The Baronette, a Renaissance Hotel by Marriott SP 09-08

Consideration of the request of Hotel Baronette for a recommendation to City Council for Preliminary Site Plan, Shared Parking Study and Storm Water Management Plan approval. The subject property is located in Section 14, south of Twelve Mile, east of Novi Road in the RC, Regional Center District. The subject property is approximately 6.29 acres and the applicant is proposing to add a three story 5,688 square foot addition to the existing Hotel Baronette, and is also proposing to extend the patio area of the existing restaurant and eliminate 26 parking spaces from the existing parking lot.

PLAN REVIEW CENTER REPORT

**SUBJECT: Hotel Baronette / Marriott Renaissance Renovation, SP#09-08,
Traffic Review of Preliminary Site Plan, Shared Parking Study,
and Traffic Impact Study**

- Birdseye aerial
- Two marked-up plan excerpts
- City of Novi standard end island details

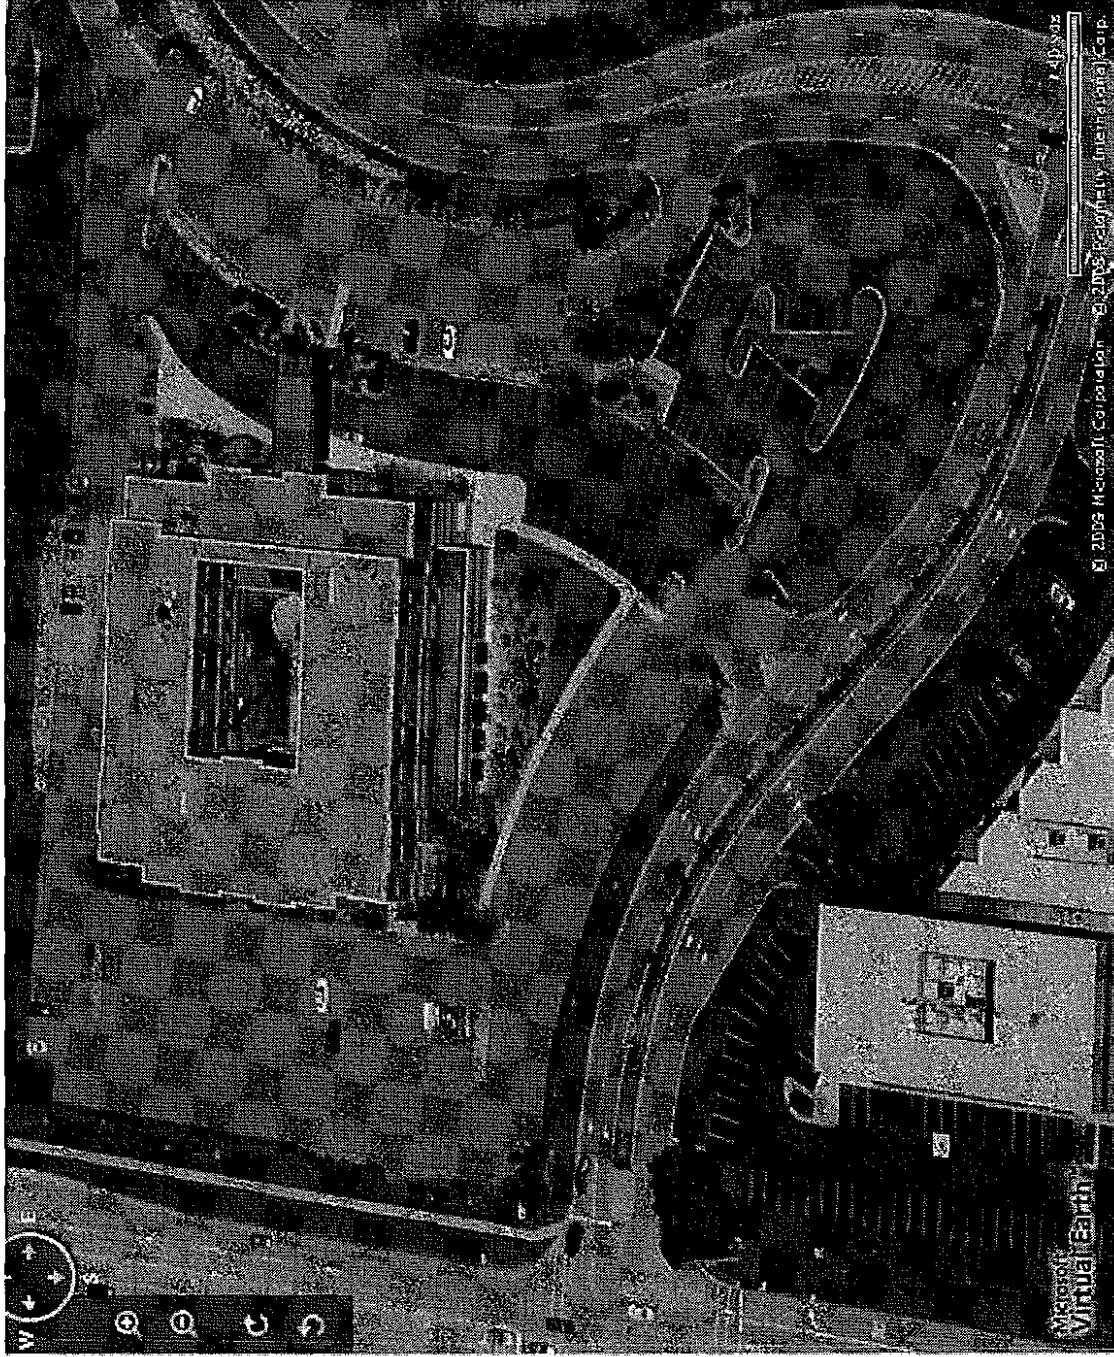
1. A **5,688-s.f.** multi-story addition is proposed at the southwest corner of the existing hotel (see attached birdseye aerial photo). According to the Applicant's shared parking study, the addition will include a **1,600-s.f.** banquet hall with **111** seats on the first floor, and a club lounge and exercise room (for hotel guests) on upper floors. Also according to the shared parking study, the new facility will be served by *the same number of employees – 75 –* now serving the existing 153-room hotel, 176-seat restaurant, and 300-seat banquet hall.

Hotel Baronette at Twelve Oaks Mall, Novi

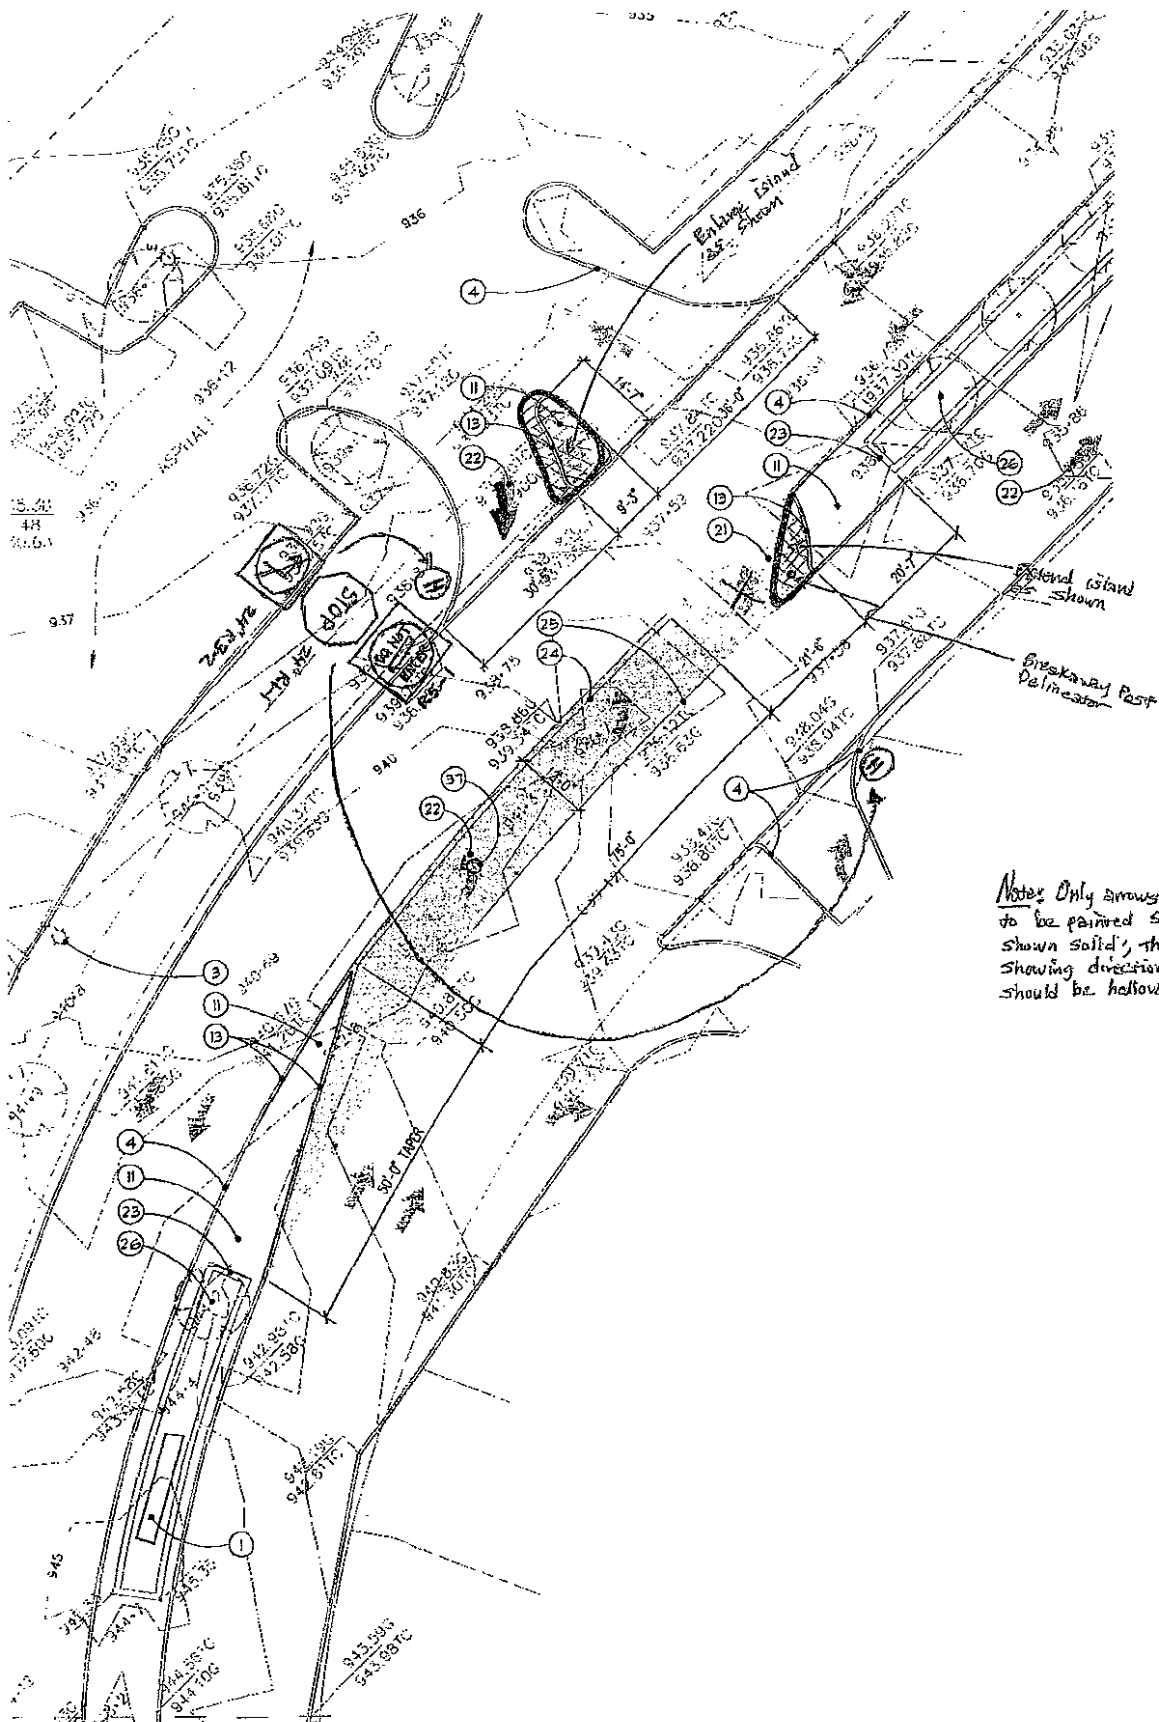
11. The plan proposes to reduce the size of the existing island in the hotel's south driveway and allow entering left turns from the mall entrance drive. **To enhance that island's visibility and provide a somewhat better physical deterrent to exiting left turns (at a location where such turns would be disruptive to mall traffic), the island should be enlarged and the exiting drive narrowed; see the first attached plan mark-up. Also, to further discourage exiting left turns, the median nose east of the hotel drive should be extended further west (also shown in the mark-up).**

12. No later than the final site plan, appropriate traffic control devices (signs and pavement arrows) should be proposed at both the modified site driveway and the existing driveway across the entrance road from the site driveway. Our recommendations in this regard are shown on the attached plan mark-up.

Standard Parking Island Design

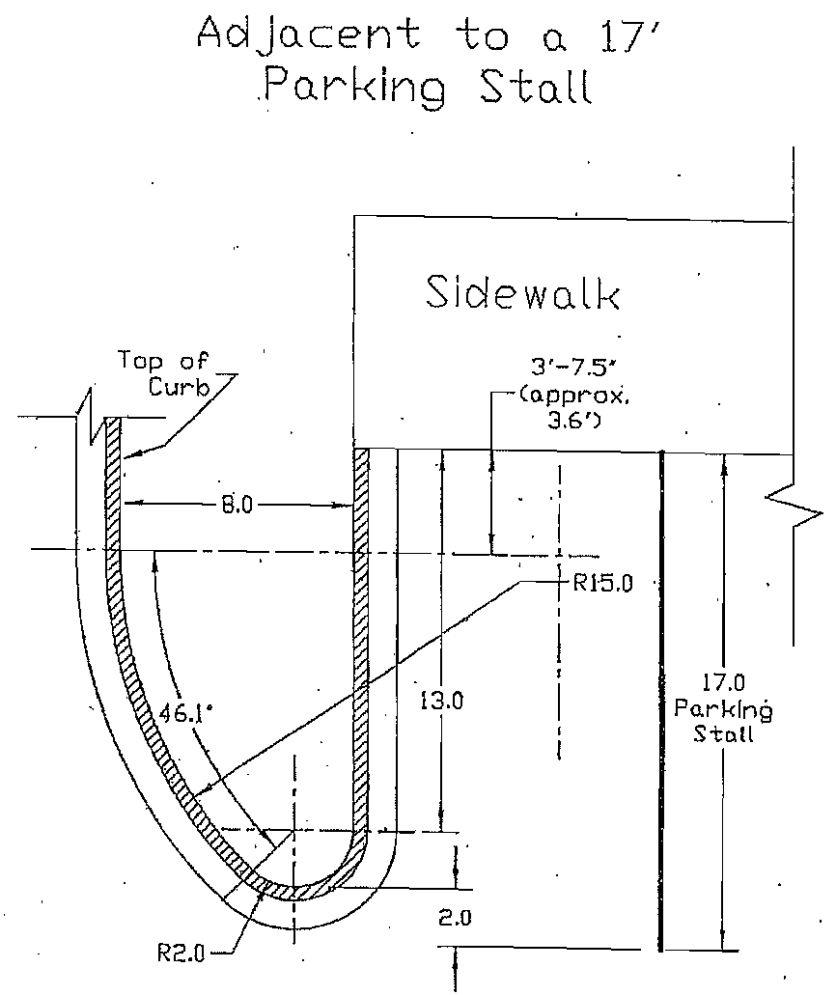
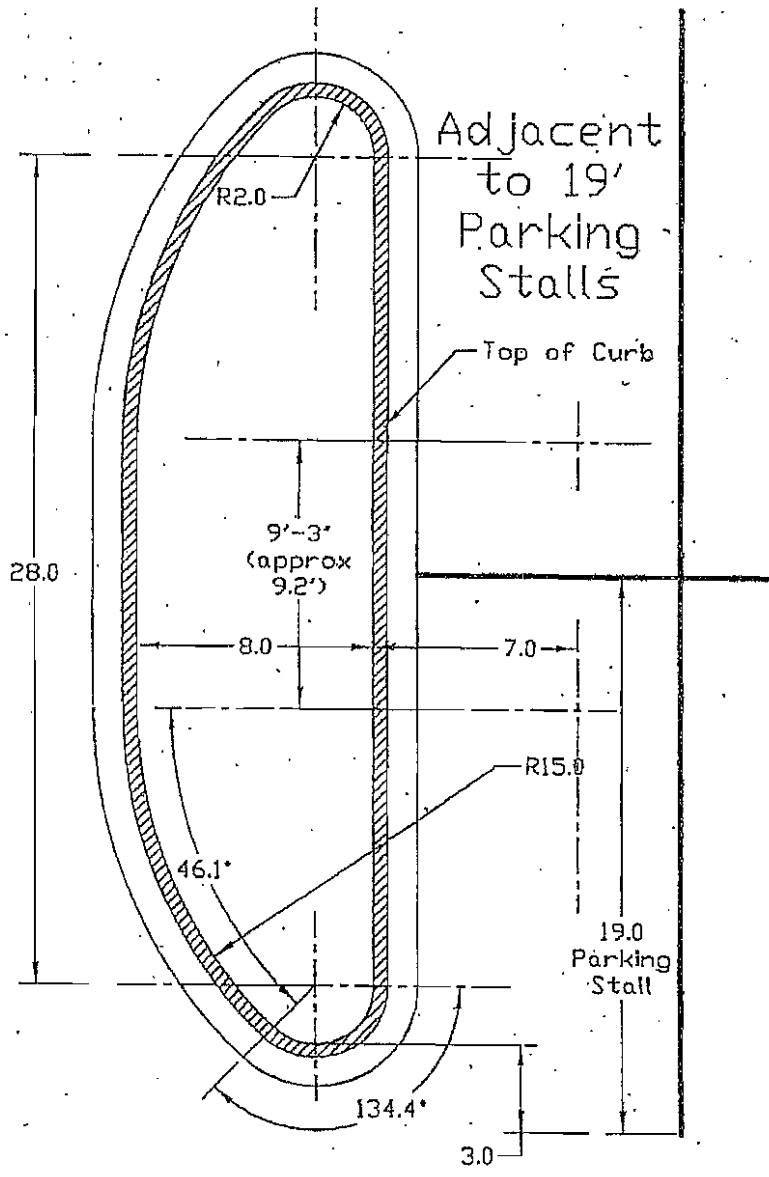
13. We were unable to find any dimensions in the plan set for the proposed new curb radii near the proposed building addition. It appears, however, that the inside corner radius between the west and south parking aisles is only 15 ft. Our review with turning templates confirms that a larger radius would be required to facilitate fire truck circulation in the event cars are parked along the south side of the lot. Also, the new end island nominally north of the addition has semicircular ends and parallel sides, contrary to the City's Zoning Ordinance (Sec 2506.13).

14. **To address the two deficiencies described in comment 13, we recommend that (a) a 25-ft inside corner radius be used, as shown in the second attached plan mark-up, and (b) the new parking lot end island be designed per the attached standard detail sheet.**

- 11.) All detectable warning surface products shall be specified as required.
- 12.) The proposed end islands shall conform to The City of Novi standards.

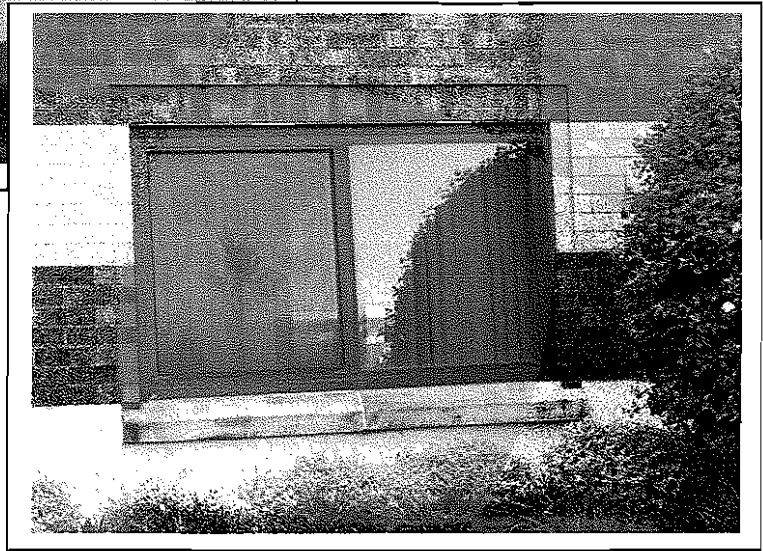
It should be noted that the stone copings and window sills on the existing building are deteriorated and unsightly and significantly detract from the buildings overall appearance. See attached photos. It is recommended that the applicant clarify weather and if so how this will be remedied as part of the proposed improvements.
